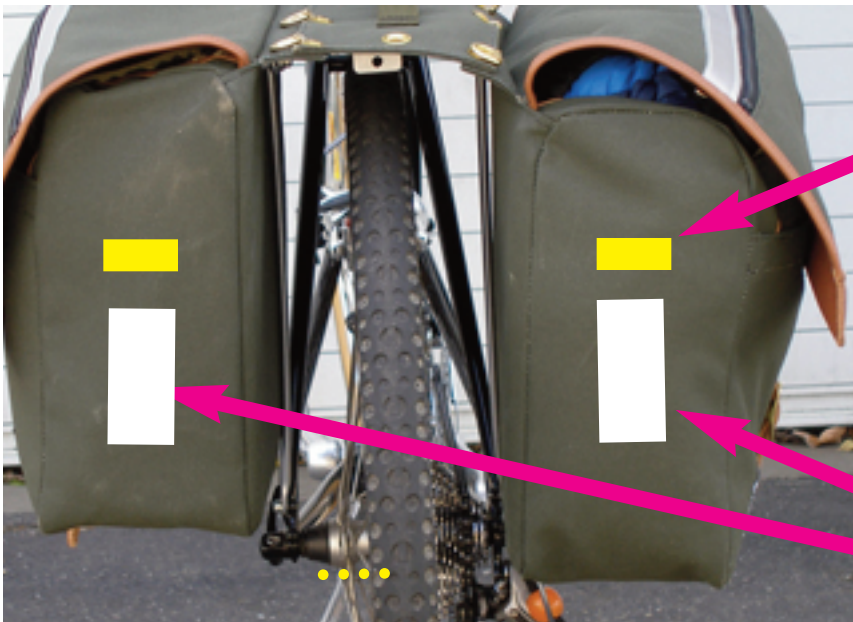
reshape this for better coverage, and it's OK to lose the countour with the front edge.

lengthen strap 2-inches so it'll reach with a too-big load, still.

these balls are groovy, likem a lot, couldn't fine or-ange. But it just occurred to me that you got orange because you got them at Home Depot. We may do that too, for the orangeness, but we're going to get 9-10 inchers, and both Dave and I have ordered them already, but in black. I like the orange, but we'll see how it goes. Some wouldabeen customers may squawk at the plastic balls, but the grommet there will let them use something more traditional..like Zip-Ties! Or whatever. Anyway, the balls work great.

put one of these in the bottom of each pouch as a drain hole. smaller is OK, doesn't matter...and reinforce as necessary or IF necessary so it doesn't rimp at the edges. I think this fabric can support a grommet, but be quadruple sure. thanks.

is it paranoia based on bad brains or a good idea to make this whole underside one piece of fabric? I don't mind the cost-due-to-waste; I just want it never to fail at a seam in 25 years or so. You know how these bags are stitched and riveted, so it's your call...but all things equal, one-piece seems groovier. We don't have a quote yet anyway, but I can handle a bit of an upcharge... Think about that and if I'm being too weird and just don't know, then stick with this.

rivet or stitch on a 3/4-in tall x 2-in wide leather or web strap for a red blinky light.

This may be a "one side only" deal too, or I may cave in to the resident symmetrists and England-Japan sympathizers and go both.

position as you see, visually. exact distance above botton no matter, but about like this.

i've got some 2--inch 3M coming, otherwise same as the other. At the last minute I may request none on this right-side pannier, and either a big one or two on the left. I'm fine with the asymmetry, and it makes sense.
